# United States Patent and Trademark Office

APPLICATION NO.	FILING DATE	FIRST NAMED INVENTOR	ATTORNEY DOCKET NO.	CONFIRMATION NO
09/954,754	09/18/2001	Charles J. Rice	4810-002	8506
24112	7590 09/27/2004		EXAMINER	
COATS & BENNETT, PLLC			NGUYEN, PHONG H	
P O BOX 5 RALEIGH, NC 27602			ART UNIT PAPER NUMBER	
Maddigit, 1	27002		3724	<del></del>

#### **DETAILED ACTION**

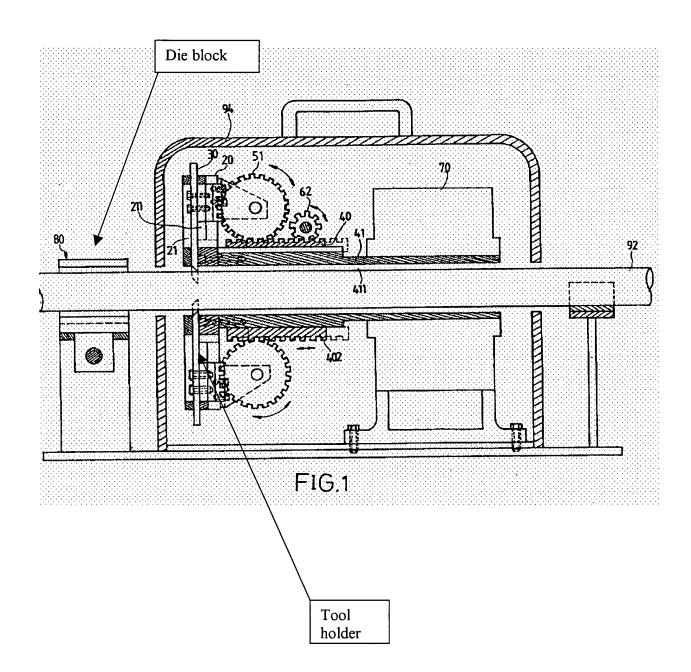
Regarding claim 35, the first and the second rotating cams are disposed on a common shaft 41. See Fig. 1.

Regarding claims 36 and 37, a first phase occurs when cutting blades are at an idle position; a second phase occurs when cutting blades cut a tube; and a third phase occurs when cutting blades return to the idle position. See Fig. 1.

Regarding claim 38, the driving cams (51 or 91) are stacked along a common axis of rotation. See Fig. 1.

Regarding claim 39, a first lobe 51, a second lobe 51, a first surface 502 and a second surface 502 are best seen in Figs. 1 and 3A.

Regarding claim 40, a first lobe 51 (at a 9 o'clock position) contacts a first surface 502 and a second lobe 51 (at a 6 o'clock position) contact a second surface 402. See Figs. 1 and 3A.

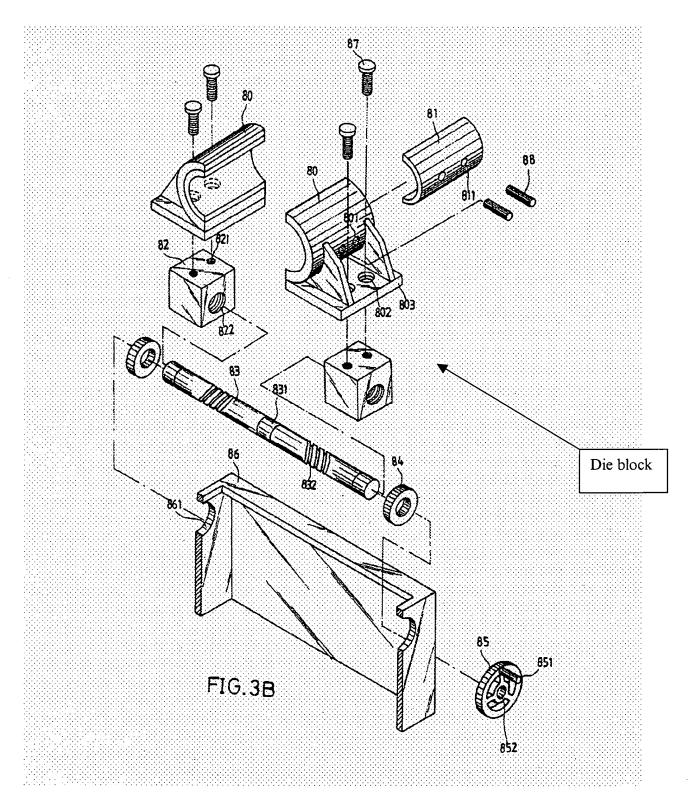
3. Claims 1, 10, 11, 13-15 and 27-28 are rejected under 35 U.S.C. 103(a) as being unpatentable over Vernacchio (4,986,154) in view of Tseng (6,269,721 B1).

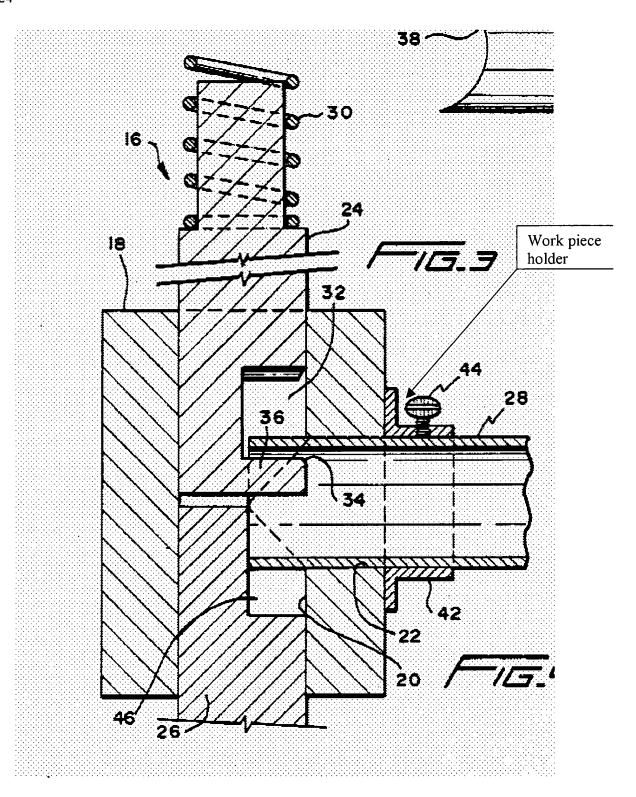
Regarding claims 1 and 15, Vernacchio teaches a tube-forming device comprising a work piece holder, a tool 36 having a cutting edge 34 and a tool holder 26. See Fig. 3. Vernacchio fails to teach a dual action-rotating cam to drive the tool holder. Tseng teaches a driving cam 30 capable of driving a tool holder. See Fig. 3. It would have been obvious to one skilled in the art to provide a cam as taught by Tseng to drive a tool holder in the Vernacchio's tube-forming device.

Tseng also teaches providing a plurality of driving cams 30 to drive a plurality of tools. See Fig. 3. It would have been obvious to one skilled in the art to provide the tube-forming device of Vernacchio two tool holders side by side, each has a driving cam as taught by Tseng to cut more tubes in less time.

Regarding claims 10 and 11, a reciprocating carrier block 26 is best seen in Fig. 3 in Vernacchio.

Regarding claim 13, 14, 27 and 28, a biasing means 30 is best seen in Fig. 3 in Vernacchio.
